# UNITED STATES PATENT AND TRADEMARK OFFICE

10/576,869

Peter Holzheu

<b>Office Action Summary</b>	<b>Application No.</b> 10/576,869	<b>Applicant(s)</b> HOLZHEU, PETER	
	<b>Examiner</b> GWENDOLYN FOURNET	<b>Art Unit</b> 4127

FIG. 2

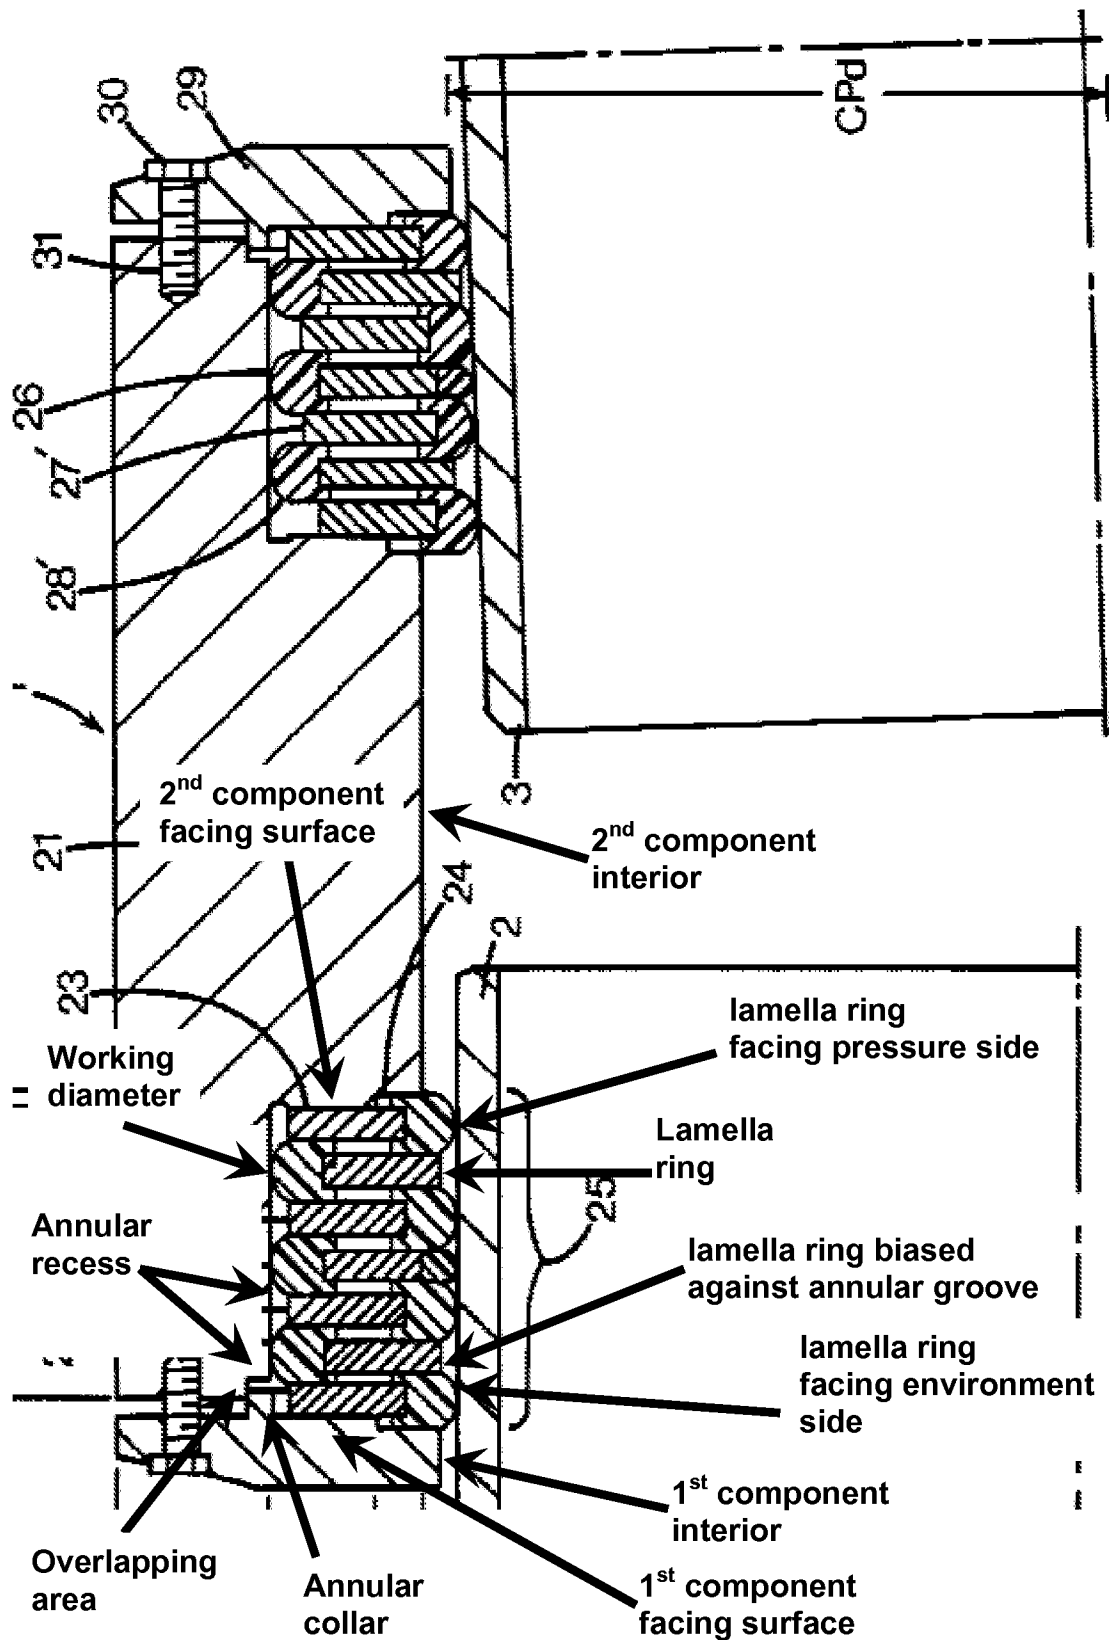
Regarding claim 1, Ekholm et al. discloses a flanged joint (see figure 2a (1)) for a pressurized medium (column 2, lines 27-29, which disclose providing a seal against different pressures), the flanged joint comprising: a first component (21) and a second component (29) having an interior (see figure 2 below);

at least one flat gasket (see figure 2b (26a)) held between facing surfaces (see figure 2 below) of the first and second components;

an annular groove (see figure 2a (22)) and a radially opposed working diameter (see figure 2 below) located between the interior and the at least one flat gasket (see figure 2 below); and

at least one lamella ring (see figure 2 below) held in the annular groove and biased, essentially without a gap, against the working diameter (see figure 2 below).

Regarding claim 5, Ekholm further discloses the plurality of lamella rings includes at least one lamella ring facing the pressure side (see figure 2 below) and at least one lamella ring facing the environment side (see figure 2 below) and those rings being biased against the working diameter (see figure 2 below), and the plurality of lamella rings includes at least one lamella ring is biased against a bottom of the annular groove and axially arranged between the at least one lamella ring facing the pressure side and the at least one ring facing the environment side (see figure 2 below).

Regarding claim 10, Ekholm further discloses the first and second components include a radial overlapping area (see figure 2 below) such that one of the components includes an axially protruding annular collar (see figure 2 below) engaging a complementary, annular recess (see figure 2 below) of the other component, the other component having an inner circumferential surface forming the working diameter (see figure 2 below).
